6 SCHEME PROPOSALS

6.1 Overview of Scheme Design

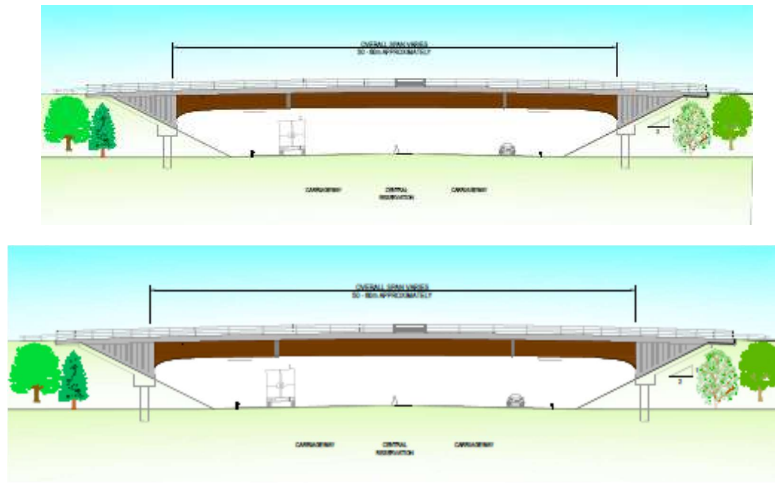
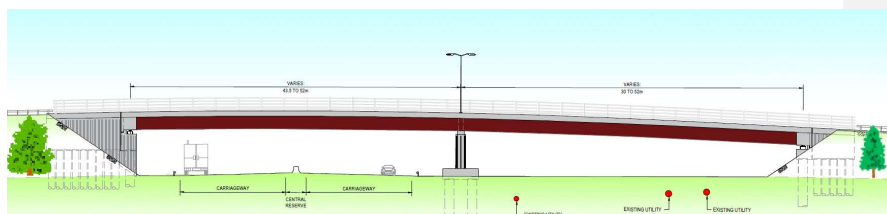
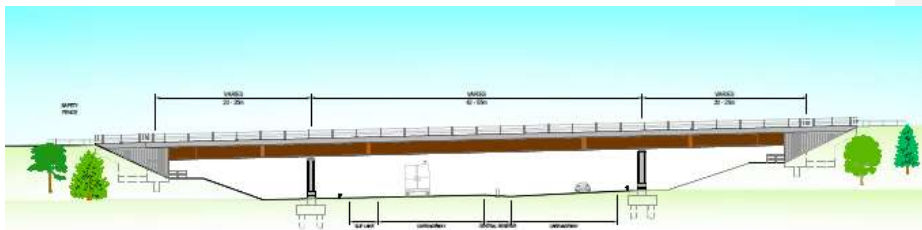
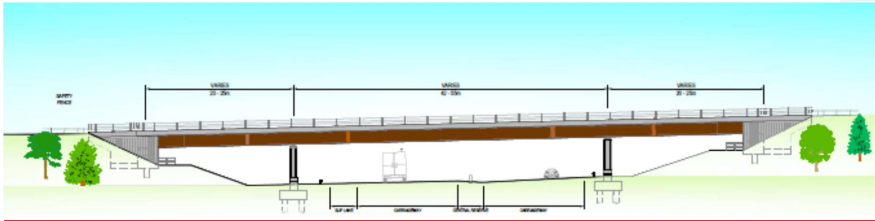
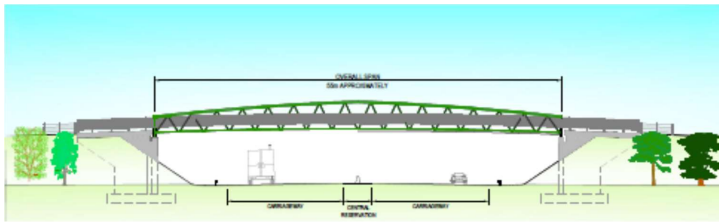
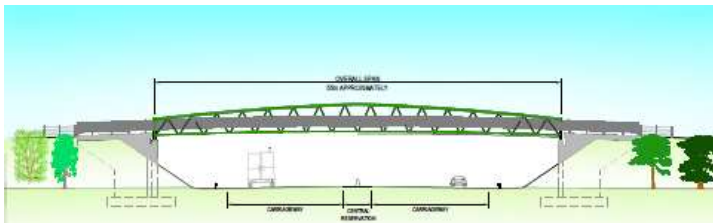
6.3.226.3.28 ~~Three There are four different overbridge span arrangements are used in the current iteration of the Preliminary Design for the Scheme;~~

a) ~~single-span deck supported on full height abutments (Figure 6). This is proposed rather than a (Figure). This is the preferred solution at most sites, because of its advantages over the multi-span options. A two-span bridge which would need requires a pier to be built in the central reserve with consequential, usually, close to live traffic delay, which leads to traffic delays, and impacts on safety, cost and programme disadvantages. It is the preferred solution at most sites;~~

a)b) ~~two-span deck supported on abutments, (Figure). This arrangement is proposed in locations where there are significant statutory utilities close to and parallel with the motorway verges. In this situation, one span of the bridge is over the widened M4, the second span is over the statutory utilities. This option is preferable because it eliminates the need for costly diversions of utilities, minimises construction work and the presence of operatives around live statutory assets.~~

a)c) ~~three-span deck with piers at the back of the verge and bank seat abutments (Figure 7) are (Figure). This arrangement is proposed for the two longest bridges: Datchet Road and Huntercombe Spur Monkey Island Lane. A three-span bridge is preferred because of construction benefits. The use of bank seats, rather than full height abutments, will reduce reduces the amount~~

a)d) _____ single-span steel truss footbridge (Figure 8).(Figure). This is suitable only for non- vehicular loading and is proposed only at Oldway Lane.
